Planning Commission Staff Report

Subject: Rezoning Vote Report

Petition: P.Z. 32-2007 MPD Investments, LLC

Re: P.Z. 32-2007 MPD Investments, LLC

Jim, Attached is a sketch of a solution for North Outer Forty at MPD investments. Would you be available to meet me Wednesday morning, the 20th? Thanks, George C:\Sharpdesk Desktop\IMAGE.PDF; Would (See attached file: IMAGE.PDF)

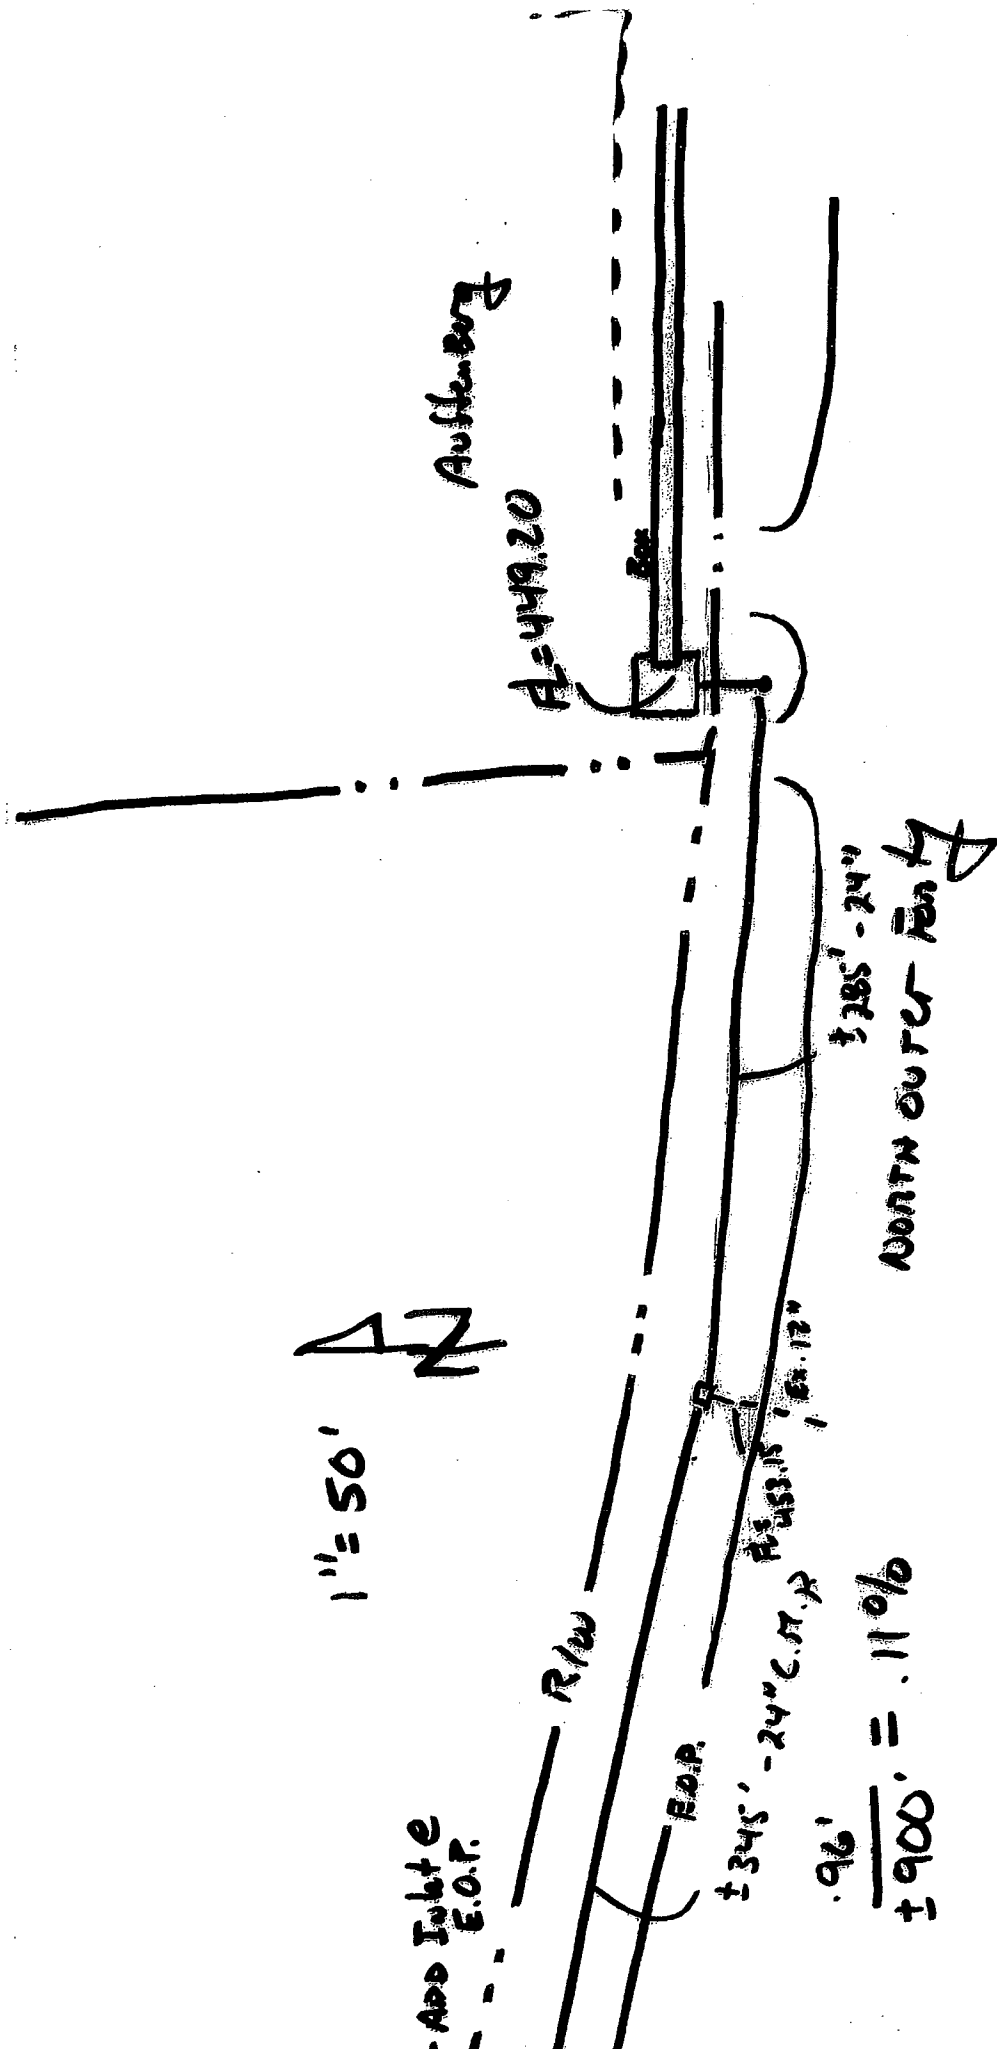
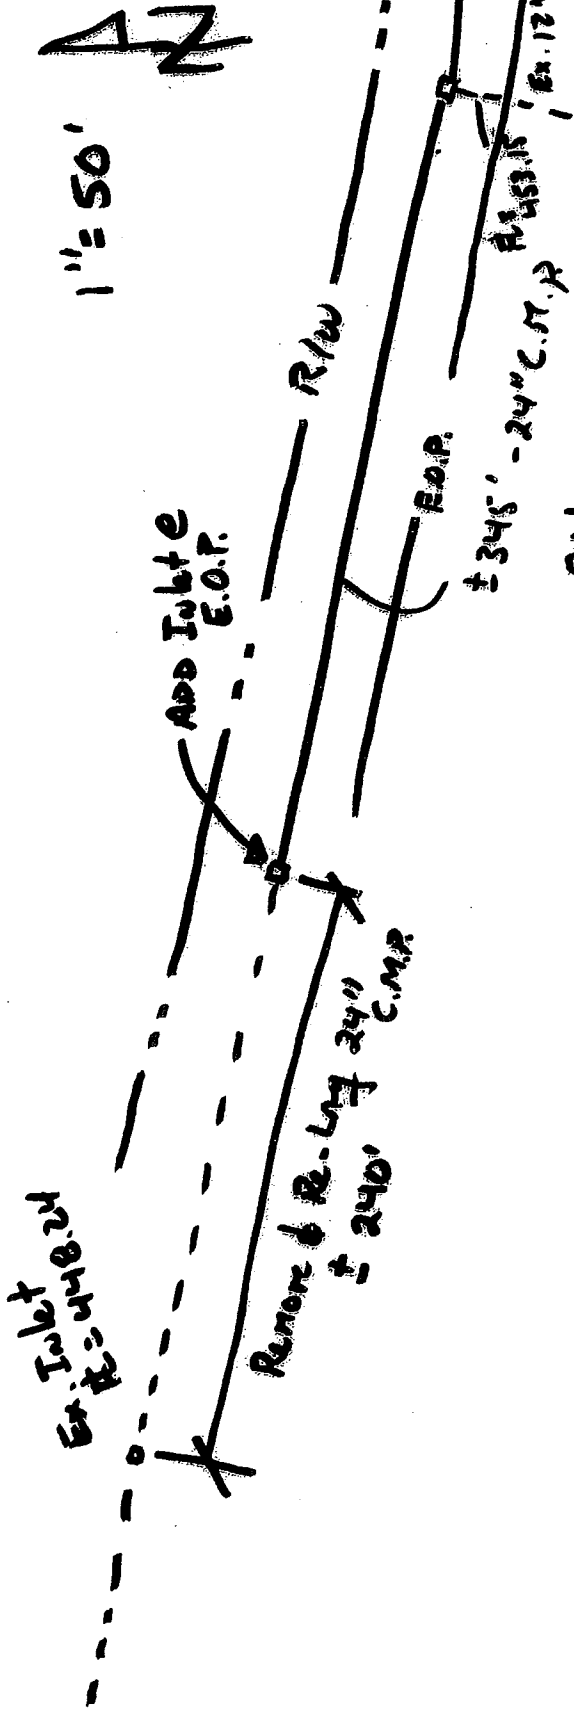
Thanks, George. As we discussed, MODOT would like some type of documentation, directed to MoDOT, to confirm that the drainage feature will be relocated to the proper easement upon development of the property.

<<IMAGE.PDF>> John/Brian, I spoke with Jim Bodart this afternoon. Jim said he has reviewed the attached solution with Karen and they are in agreement with this solution as a "Temporary " solution. Assuming that the property at such time as they zone or move forward to develop will be obligated to build the ultimate channel or enclosed structure as directed by the City. Thanks, George

As part of the MPD Investment project, a box culvert will be constructed within a Chesterfield Valley Stormwater Easement adjacent to the outer road, from the MPD site to the western edge of the Chesterfield Valley Power Sports parcel. The culvert will discharge, on a temporary basis, into the existing temporary drainage system that is located within MoDOT right of way, adjacent to the Save Gasoline parcel. This system conveys stormwater to the existing pump station to the west.
